Subject: **Revised Information in response to the On-Hold Letter for Section 401 Water Quality Certification** for the proposed replacement of Bridge No. 47 over the Lumber River on US 401 in Scotland and Hoke Counties, Federal Aid Project No. BRNHS-401(14); Division 8; TIP No. B-4273

Reference: Permit Application dated August 20, 2012
NCDWQ On-Hold Letter dated October 18, 2012

Subject: Proposed improvements to Bridge No. 32 on SR 2361 in Rockingham County, Federal Aid
Project No. BRZ-2361(1), State Project No. WBS 4024111, TIP B-4963.

STORMWATER MANAGEMENT PLAN

DETAIL
(NOT TO SCALE)
DOUBLE-BARREL
LOW FLOW CHANNEL, SILL
AND FLOOD PLAIN

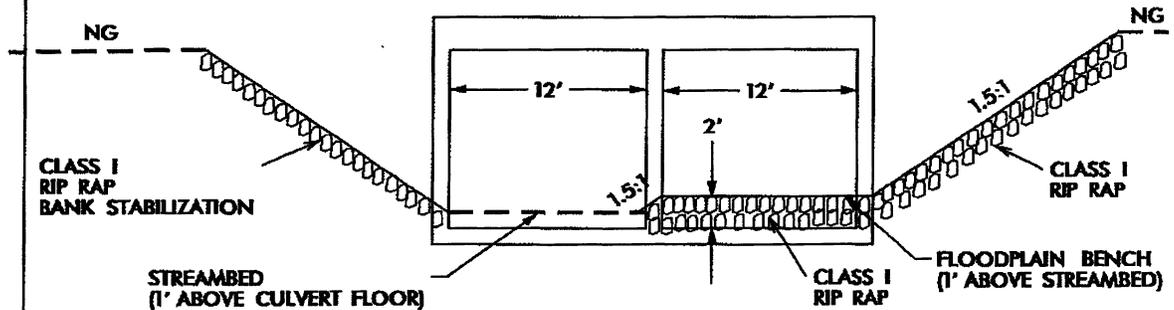
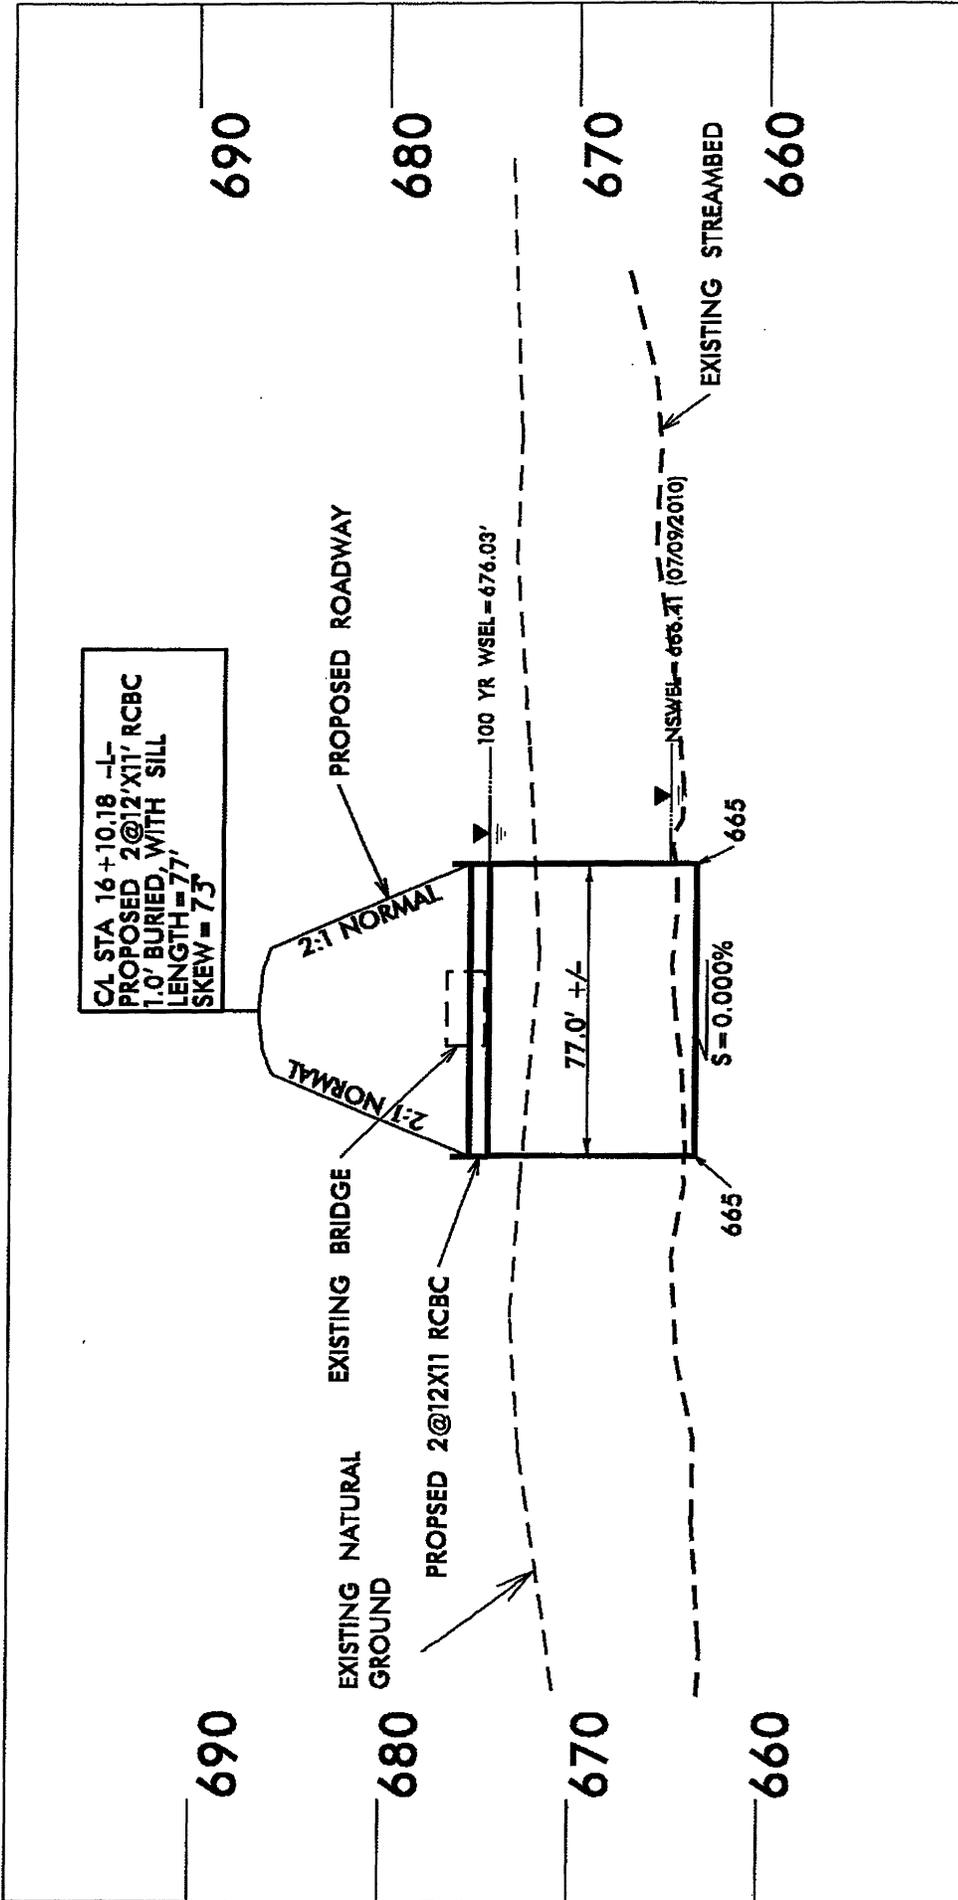
- **Constructed floodplain benches need to be added at the inlet and outlet of the overflow barrel. This information was requested by previously requested by phone; however, the updated drawings haven't been received.**

CA STA 16+10.18 -L-
 PROPOSED 2@12'X11' RCBC
 1.0' BURIED, WITH SILL
 LENGTH = 77'
 SKEW = 73'
